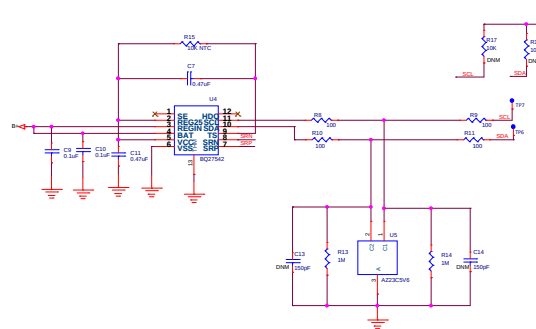
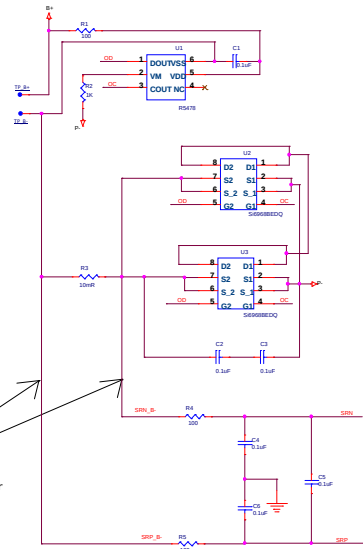
SRP_B- and GND should be same in layout

Differential route for sense resistor

SPARK GAP FOR ESD PROTECTION
